Evaluation and Findings Report

Section 401 Water Quality Certification for the Jordan Cove Energy Project

May 2019

State of Oregon
Department of
Environmental
Quality

Figure 3: Schematic of Ridgetop Right-of-Way

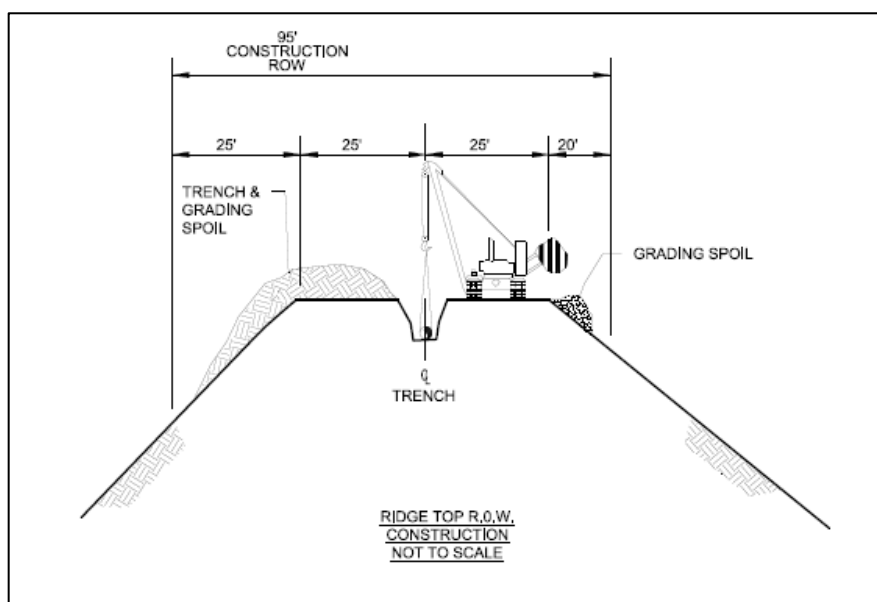
Although not delineated on JCEP’s Environmental Alignment Sheets (Resource Report 1, Appendix H.1) or discussed in their Erosion Control and Revegetation Plan, typical drawings for right-of-way cross-sections in Resource Report 1 clearly show the use of a construction access road in the right-of-way. Without a durable surface, the soil in this corridor would experience compaction during the construction of the right-of-way, and during the trenching for pipe installation. The resulting soil compaction would increase runoff and, subsequently, erosion of native soils via rill and gully erosion without additional BMPs for the construction access road surface.

JCEP has not provided BMPs for the 229-mile construction access roadway in the form design standards, specifications, and measures necessary to support the anticipated traffic load.¹⁴ For example, design standards would inform the construction of the road surface based on estimated traffic load. Design manuals are available that provide BMPs for a stabilized construction roadway where displacement of soil occurs due to vehicle traffic.¹⁵

Construction access road design standards and specifications as well as design drawings should also guide construction of the 229-mile access road drainage system and the treatment controls for its discharge. These standards and specifications and their inclusion in design plans would influence the selection of discharge points that direct stormwater discharge to structural stormwater treatment controls or vegetated areas with permeable soils.

Figure 5: Spoil Placement on Headwalls for Construction ROW and TEWA 8.72-W between MP 8.56 – 8.75

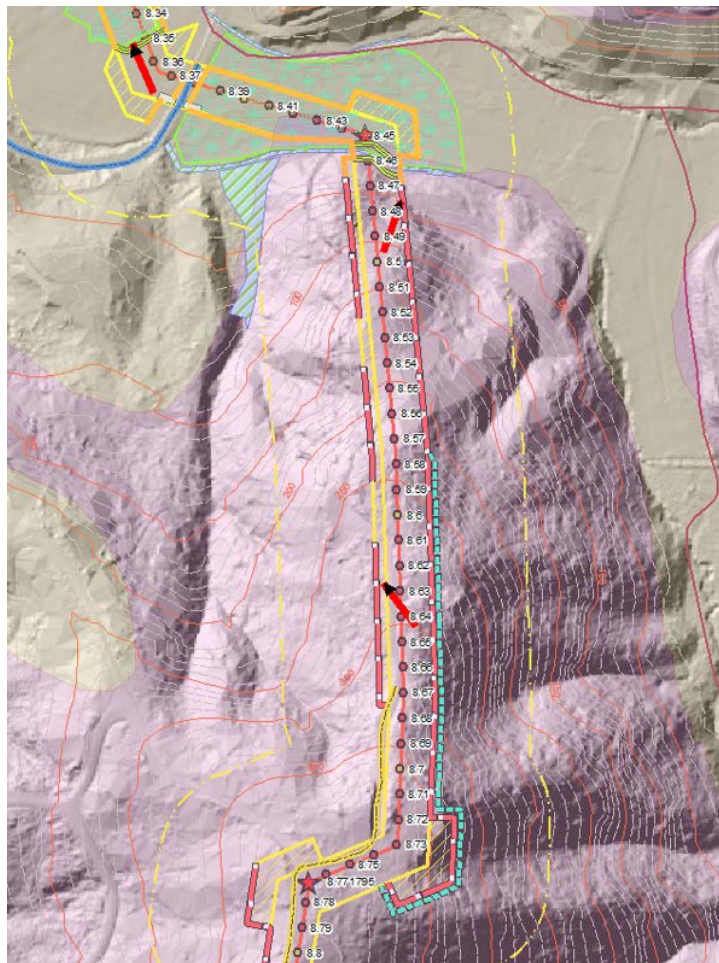
In the January 31, 2019 meeting to discuss the September 7, 2018 information request, JCEP presented a segment of the pipeline overlay on a Light Detection and Ranging Map (see Figure 5). This LiDAR map segment clearly shows the working side of the construction ROW with its construction access road and Temporary Extra Work Area above three headwalls (i.e., unstable slopes). As discussed above, these areas would support trenching and grading spoils and may require fill to level this working surface. The weight of the fill and/or trench and grading spoils, the anticipated traffic loads, and the stored material in combination with additional runoff due to the lack of a forest canopy present a substantial water quality risk to streams as well as a risk to worker and public safety.

Figure 6: Fill Placement on Headwalls for Construction Right-of-Way and TEWA 10.71-W MP 10.78 – 10.87

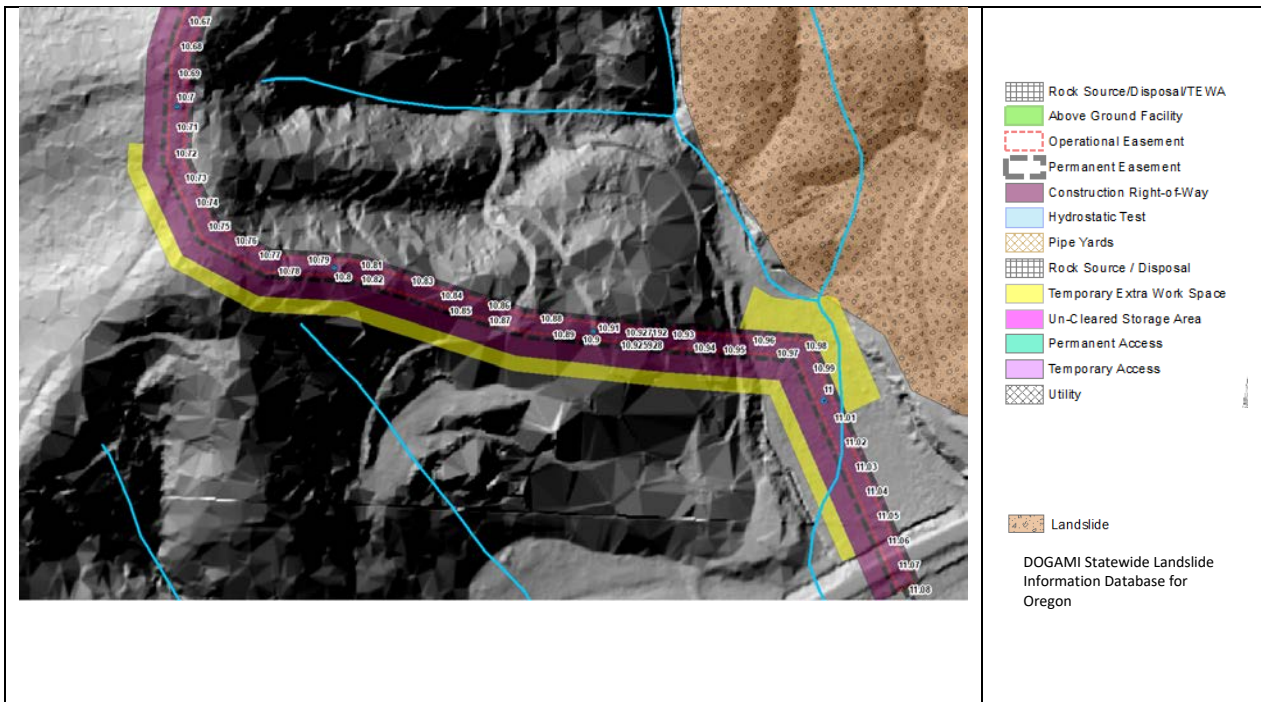
On Page 31 in Section 4.5.3.2 of Resource Report 5 (Geologic Resources), JCEP indicates it used LiDAR, 10-meter DEM, and aerial photography to identify moderate and high RML sites. This section provides the risk criteria JCEP used to identify the RML sites selected for surface reconnaissance and included in Table B-3a. JCEP's selection criteria was to identify the potential for a RML to induce strain on the pipeline and for RML erosion to expose a pipeline. These two selection criteria would not ensure the identification of RML sites posing a risk to streams and water quality. The above quality assurance check confirmed DEQ's concerns presented in the December 20, 2018 information request that JCEP's landslide hazard evaluation did not consider the landslide hazard risks to streams initiated by the construction and operational ROW.

Figure 8: Map of Hudson Creek-North Fork Coquille Subwatershed

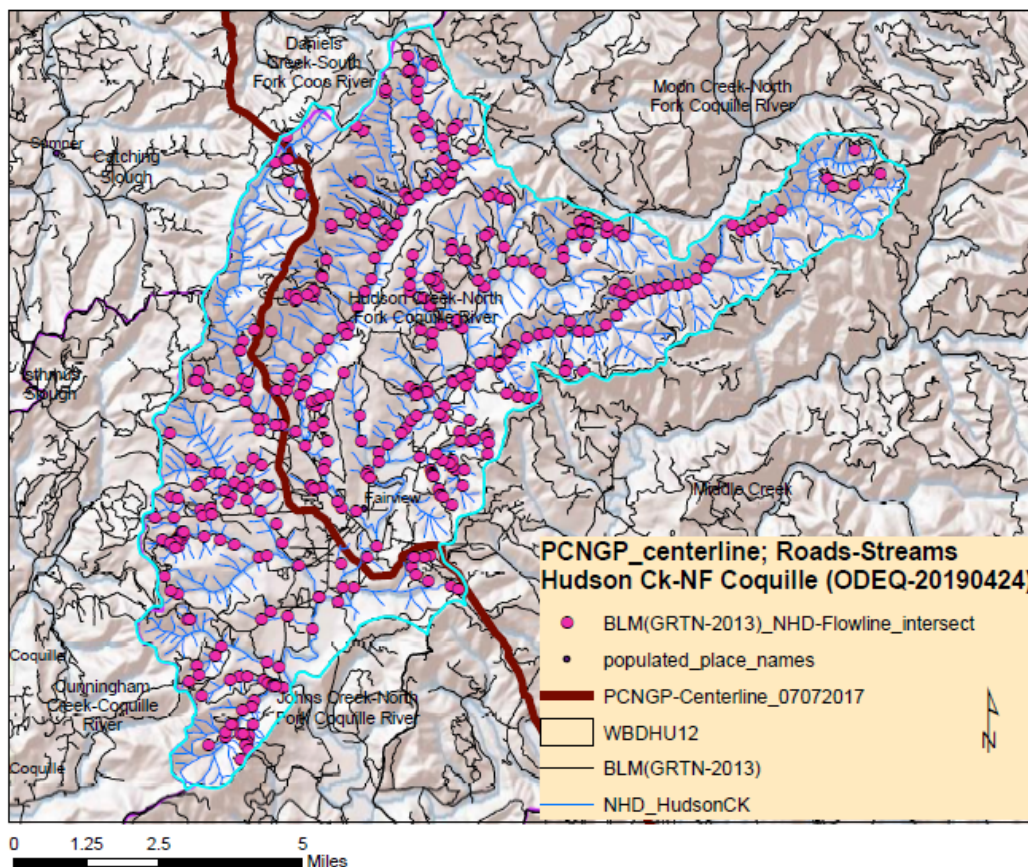
As a sample of road-stream intersections in the highly dissected drainage basins of the Coast and Cascade Ranges, Figure 8 shows the number of BLM road-stream crossings in just one of numerous subwatersheds where the construction ROW is located. This map does not include cross drains for roads that are also within 200 feet of a stream and, therefore, hydrologically connected to this stream. If a field inventory included cross drains, the number of road-stream interactions on this map would be greater than currently displayed in Figure 8. Many of the BLM roads depicted in the map below would serve as an existing access road for pipeline construction. Given this small area, JCEP's estimate of 21 existing access roads that could potentially deliver sediment is a significant underestimation.

Figure 9: Construction Right-of-Way Above Headwall

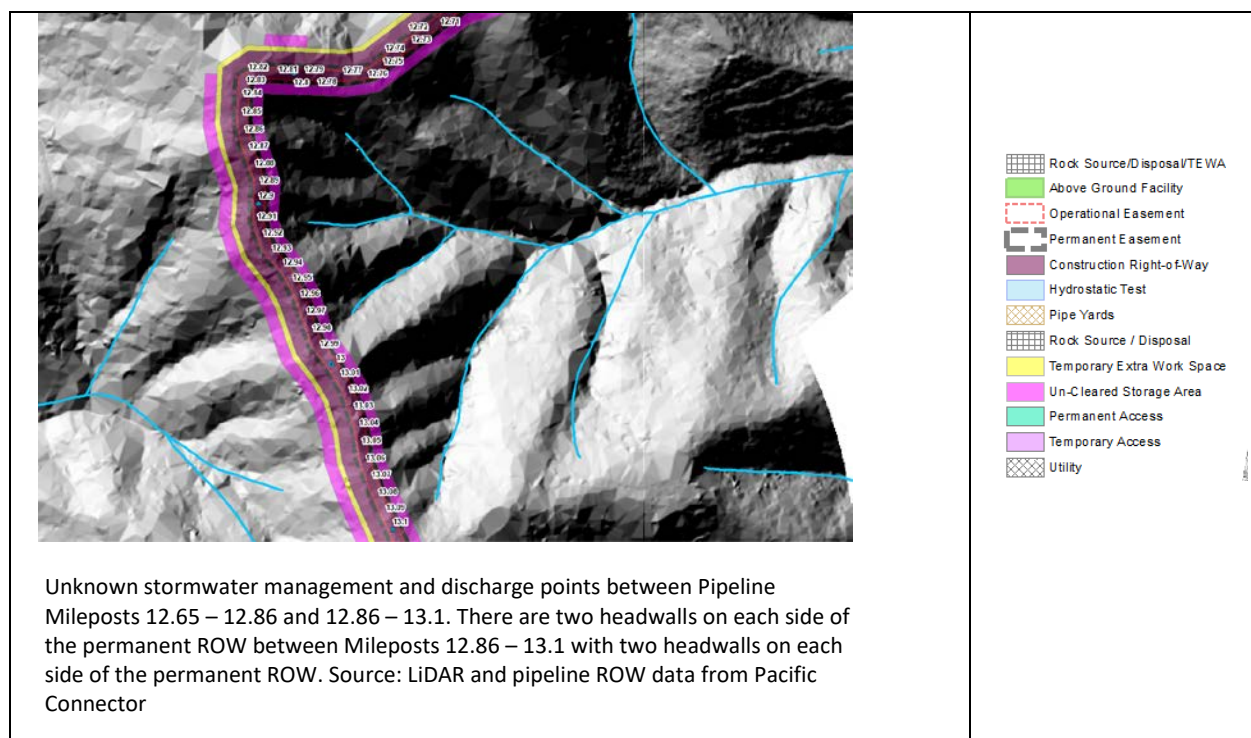
To ensure compliance with statewide narrative criteria OAR 340-041-0007(1), DEQ developed the *Section 401 Water Quality Certification Post-Construction Stormwater Management Plan Submission Guidelines* (March 2018). In Section E.2.2 of these plan submission guidelines, DEQ requests that project proponents determine if infiltration of stormwater discharge should be avoided due to steep slopes or landslide risks (see Page 9). The proposed permanent ROW traverses over and along unstable slopes in numerous locations. For example, Figure 9 below shows sections of the permanent ROW above headwalls. JCEP has not provided DEQ with a post-construction stormwater plan for the permanent ROW demonstrating how JCEP would manage stormwater along the permanent ROW and, in particular, along landslide susceptibility zones. As discussed in Section 6.1.2.1 of this Evaluation and Findings Report, the stormwater discharge from slope breakers can reduce slope stability.

Figure 10: Pipeline Parallel to and Crossing Spencer Creek and crossing Clover Creek, near Milepost 177

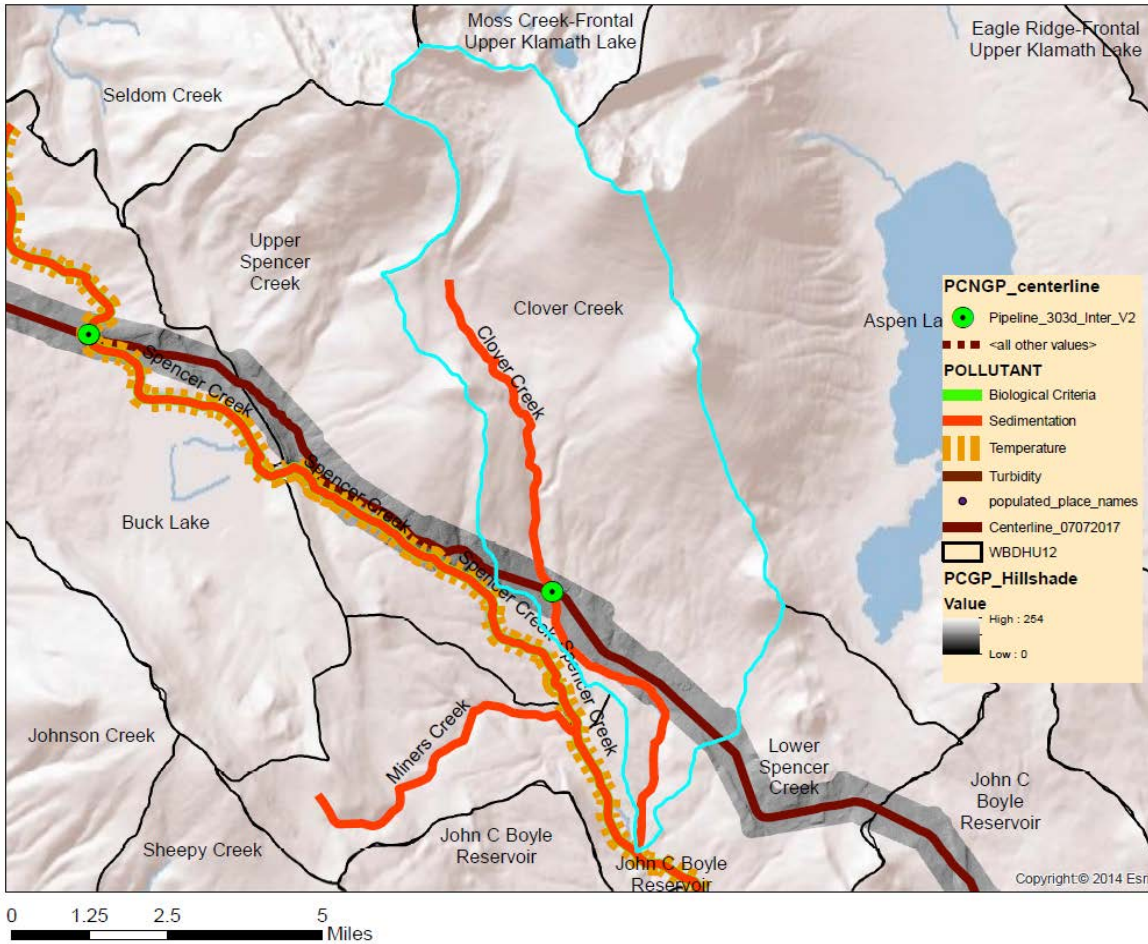
Figure 10 shows one of several examples of the permanent ROW crossing or paralleling streams on the 303(d) list for sediment or crossing streams discharging to these sediment-listed streams. Based on its proposed conceptual approach for operating the ROW, the permanent ROW has the potential to discharge sediment at stream crossings. Ongoing increases in sediment loading to a waterbody that is listed on the 303(d) list for sediment in not allowed without either a TMDL allocation, or an implementation plan showing that there will be no increase in loading. OAR 340-41-0004(7)(“Water quality limited waters may not be further degraded except in accordance with paragraphs (9)(a)(B), (C) and (D) of this rule.”⁶⁵JCEP has not provided the analyses for the discharges that would

For example, given the proposed pipeline route, Figure 10 shows the potential for the loss of effective shade from the construction right-of-way as the pipeline parallels Spencer Creek near Milepost 177. Spencer Creek is listed as impaired for temperature. JCEP informed DEQ that the riparian impacts from TEWAs and impacts from FERC's 15-foot buffer requirement, noted above, were not included in the 2017 Thermal Impact Assessment. DEQ requested that JCEP include these impacts in a revised assessment. To-date, JCEP has not provided this revision.

In sum, DEQ cannot determine if JCEP avoided or minimized proposed impacts to riparian shade particularly for streams listed as impaired for temperature and currently under a TMDL such as Spencer Creek shown in Figure 10.

Figure 10 shows the potential for the loss of effective shade from the permanent right-of-way as the pipeline parallels Spencer Creek near Milepost 177. DEQ listed Spencer Creek as impaired for temperature. JCEP informed DEQ that the riparian impacts from FERC's 15-foot buffer requirement, noted above, were not included in the 2017 Thermal Impact Assessment. DEQ requested that JCEP include these impacts in their assessment and provide a revised assessment.

Figure 11: Potential Dredge Disposal Areas Relative to LNG Terminal and Adjacent Wetlands

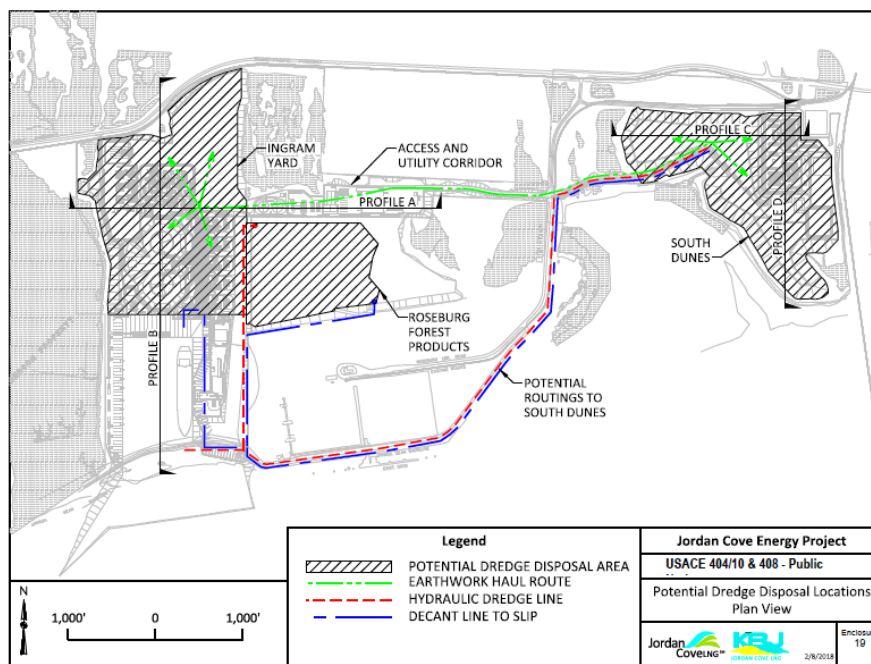
In its October 8, 2018 response to DEQ’s September 7, 2018 information request, JCEP referred DEQ to Potential Dredge Disposal Locations featured in Enclosures 19 – 22 of Part 1, Appendix N-5 of the 401 Water Quality Package. DEQ presents Enclosure 19 below to highlight the lack of detailed practices to manage the wetlands – shaded gray – adjacent to proposed dredging disposal areas:

Enclosure 19 does not show structural controls to demonstrate saline leachate or decant from dredged material would not discharge to adjacent freshwater wetlands. JCEP has not indicated how it would place containment

Figure 12: Proposed Finish Grade of Dredge Soil Locations

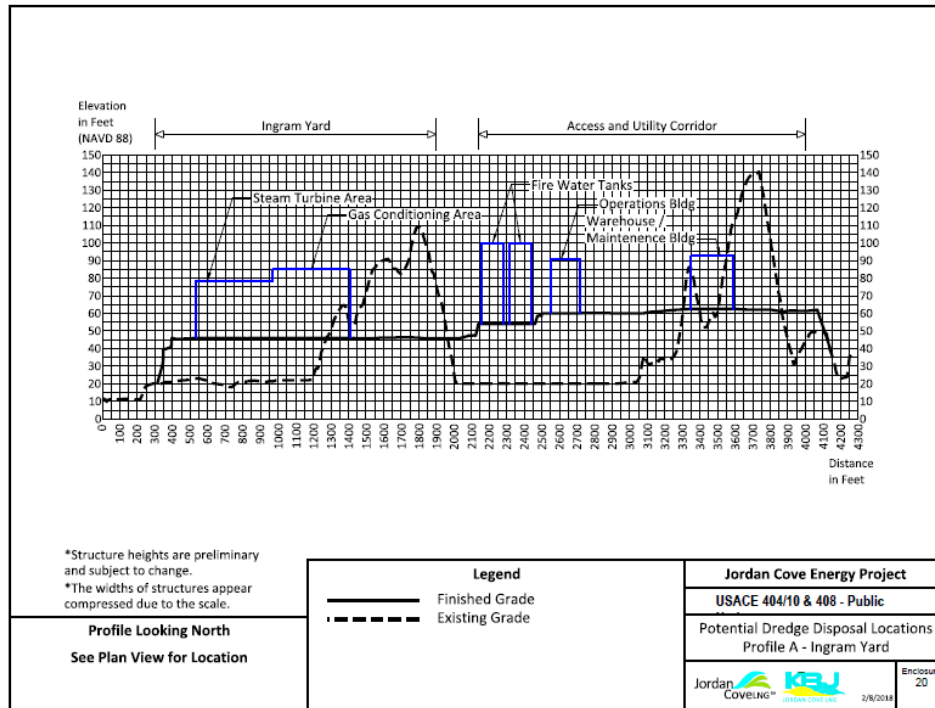
structures around the dredged material nor change the grade to direct decant to the dredge line, size a collection basin to capture the decant, operate a pump to transfer the decant to a discharge location, or propose a discharge location. Enclosures 20 – 22 only provide the elevation of dredge material as shown in Figure 12.

For upland confined dredge disposal facilities, the State of New Jersey requires project proponent to consider five factors in the placement of dredged material. These factors are illustrative on what DEQ would consider in evaluating a proposal with the required information. These factors are:

Figure 13: Lick Creek and Little Butte Creek Vicinity

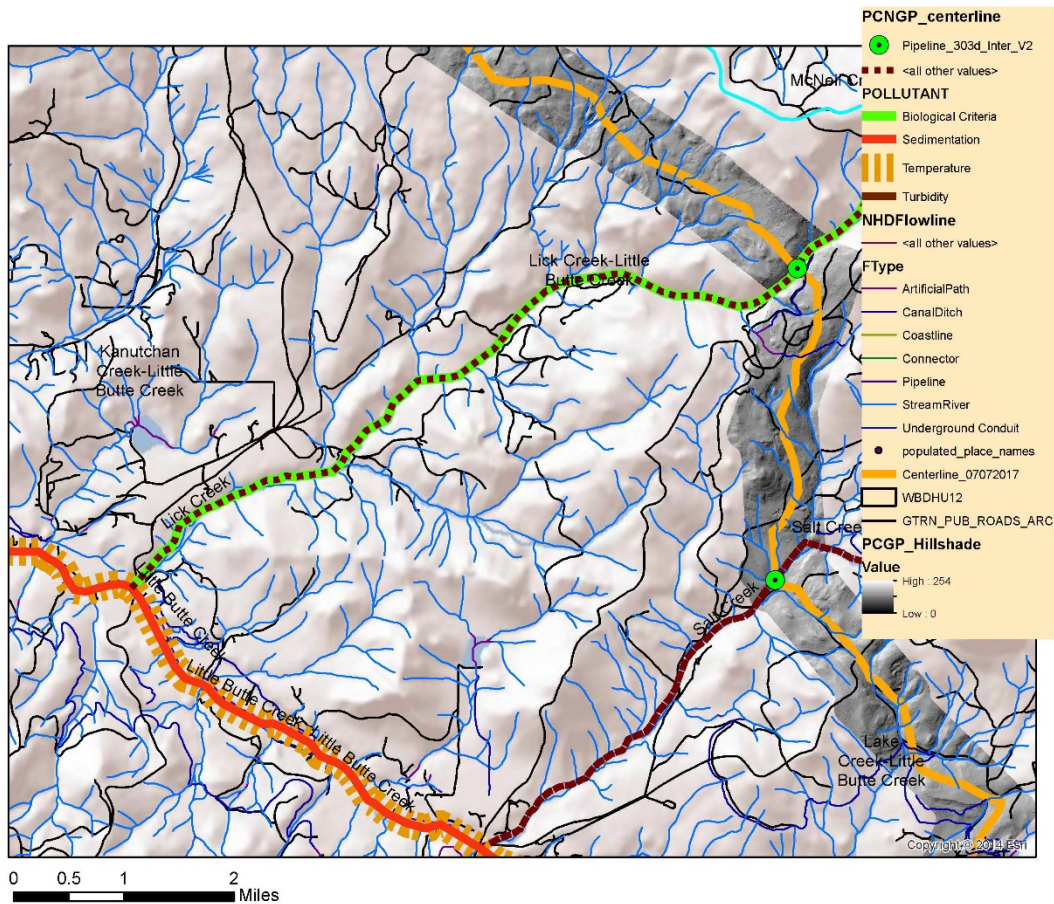
Figure 13 shows the JCEP Gas Pipeline crossing tributaries to Lick Creek and crossing Lick Creek near Milepost 140.27. Lick Creek is listed on the 303(d) List for biocriteria. Sediment discharge from pipeline construction and debris flows from landslides initiated by the construction of the right-of-way could affect aquatic life in Lick Creek and the attainment of the biocriteria standard in this impaired waterbody. As noted earlier in this report, for a 303(d) listed waterbody, without a TMDL, no ongoing detrimental impact is authorized. Although natural landslides are an integral part of stream form and function, human-caused debris torrents and sedimentation impact water quality by changing the natural cycles of sediment delivery to systems, which impacts the aquatic environment; thus, affecting aquatic life (Castro and Reckendorf 1995).

JCEP has not demonstrated that methods employed in pipeline construction, the development of the construction ROW, and the use of the construction access roads would sufficiently protect State waters to avoid detrimental changes in resident biological communities to comply with Oregon’s biocriteria standard. The following information would be needed in order for DEQ to have a reasonable assurance that the biocriteria standard will be met:

Figure 15: Pipeline Crossing at Wetland S1-04 (Willanch Slough) showing no “neckdown” of the ROW

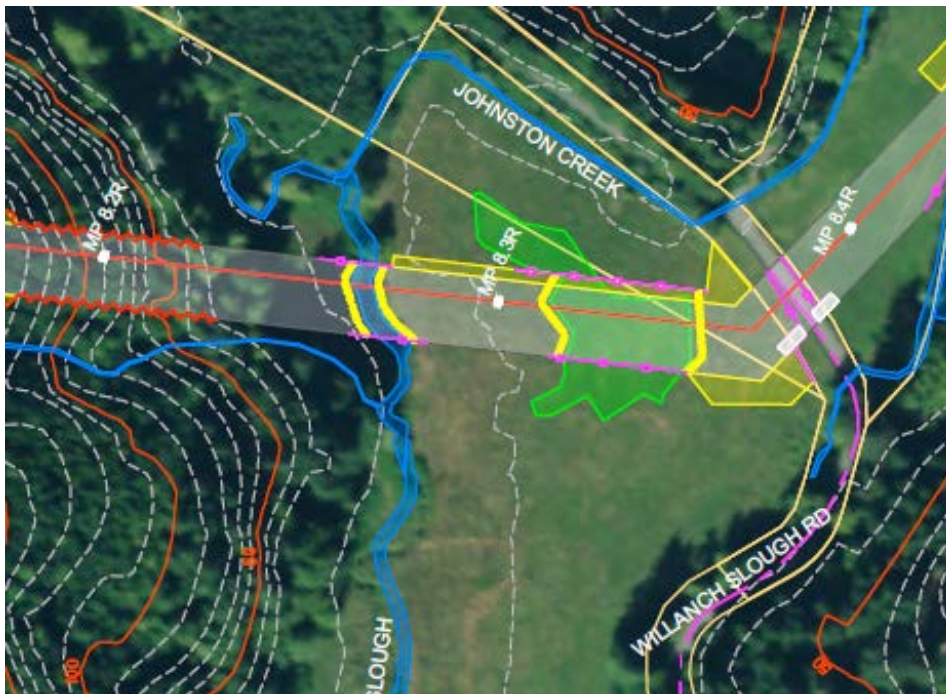
As an illustration of the reasons for DEQ's concerns about the temperature impacts of the proposed Project, at pipeline stream crossing at Milepost 58.78, Ollala Creek is limited for temperature year round and is under an approved TMDL. Similarly, DEQ has placed Rice Creek (Milepost 65.76), South Umpqua River (Milepost 71.27), North Myrtle Creek (Milepost 79.12), South Myrtle Creek (Milepost 81.19), and many others on the 303(d) list for temperature. These streams are under an approved temperature TMDL.
